APPROVED DRAWINGS HAVE BEEN RED LINED INDICATING A CHANGE TO MEET THE OBC. PLEASE REVIEW ALL PAGES TO ENSURE YOU ARE PROPERLY INFORMED OF CHANGES.

Tice River Homes
Legacy

model SD-02
scale 3/16" = 1'0"
project # 17052
page **A0**

A2

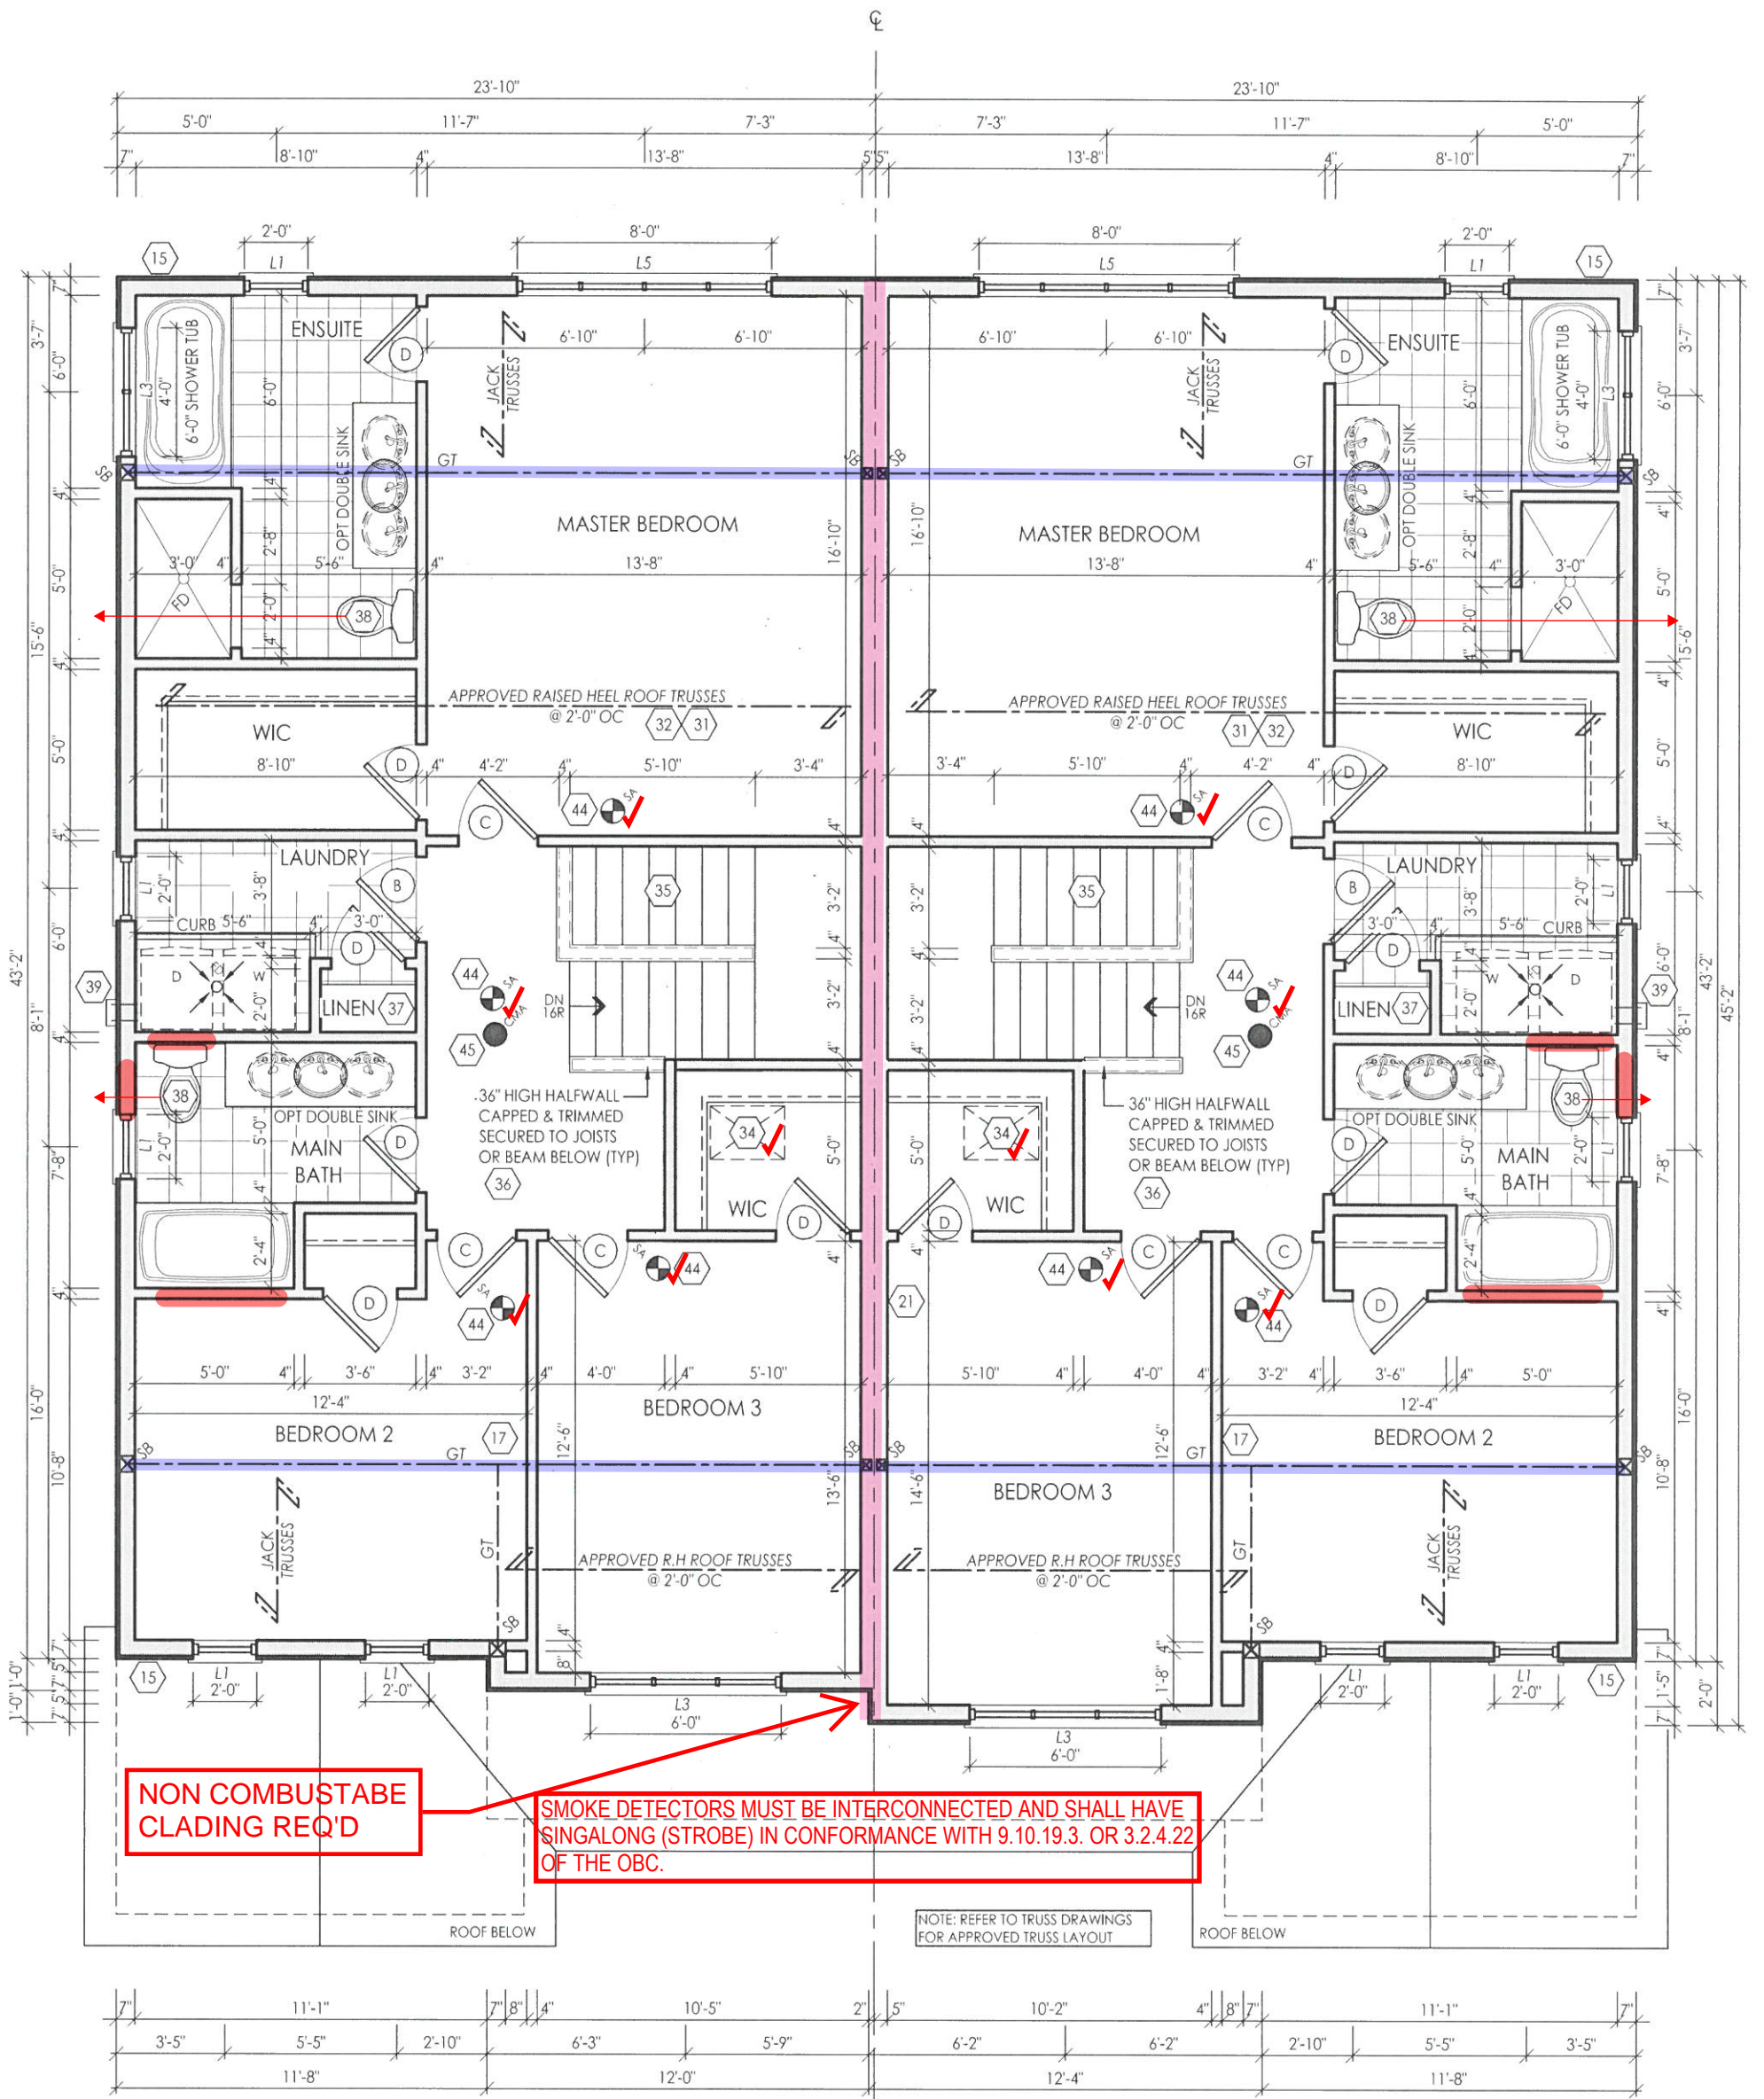
NON COMBUSTABLE CLADDING REQ'D

SMOKE DETECTORS MUST BE INTERCONNECTED AND SHALL HAVE SINGALONG (STROBE) IN CONFORMANCE WITH 9.10.19.3. OR 3.2.4.22 OF THE OBC.

A3

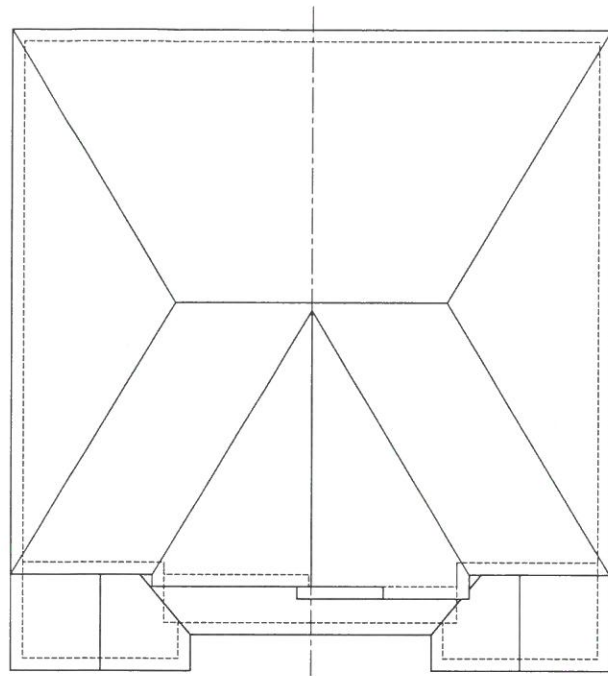
REINFORCEMENT IS REQUIRED FOR THE FUTURE INSTALLATION OF GRAB BARS FOR THE TOILET, SHOWER AND BATHTUB IN THE MAIN BATHROOM AS PER OBC 3.3.4.9.
